Access Compliance Report

Public Rights-of-Way

Intersection ID: 21411	Main Street: MONROE_RD	Cross Street: SARDIS_RD_NORTH	Location: SW
ADA ID: 99D717936B23	Ramp Type: Para	Initial Pass/Fail: Fail	Overall Compliance: No
			Severity Score: 13.75

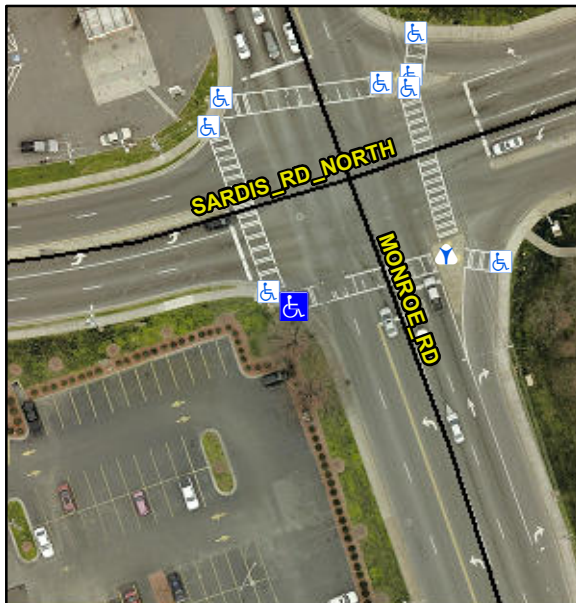
RT RP < 5%

R304.3.2, R304.5.3

Compliance	Description	Data	Compliance	Description	Data
N/A	Ramp Length LT (in)	63.0	N/A	Ramp Length RT (in)	65.0
Yes	Ramp Width LT (in)	59.0	Yes	Ramp Width RT (in)	60.0
No	Ramp Slope LT (%)	9.3	Yes	Ramp Slope RT (%)	3.0
Yes	Ramp XSlope LT (%)	0.8	No	Ramp XSlope RT (%)	3.8
N/A	Landing Length (in)	N/A	N/A	DWS Provided?	N/A
N/A	Landing Width (in)	N/A	N/A	DWS Contrast?	N/A
N/A	Landing Slope (%)	N/A	N/A	DWS Length (in)	N/A
N/A	Landing X Slope (%)	N/A	N/A	DWS Full Width?	N/A
N/A	Landing Curb? (Y/N)	N/A	N/A	DWS Offset (in)	N/A
N/A	Shared Landing?	N/A			
N/A	Gutter Ponding?	N/A	N/A	Gutter Slope (%)	N/A
N/A	Gutter Lip Ht (in)	N/A	N/A	Gutter X Slope (%)	N/A
N/A	Painted X Walk1?	Yes	N/A	Painted X Walk2?	N/A
	X Walk 1 Direction	To NE		X Walk 2 Direction	N/A
N/A	X Walk 1 Width (in)	108.0	N/A	X Walk 2 Width (in)	N/A
	X Walk 1 Slope (%)	0.9		X Walk 2 Slope (%)	N/A
	X Walk 1 X Slope (%)	3.6		X Walk 2 X Slope (%)	N/A
N/A	Ramp inside XWalk1?	Yes	N/A	Ramp inside XWalk2?	N/A

Remove & Replace Entire Ramp.
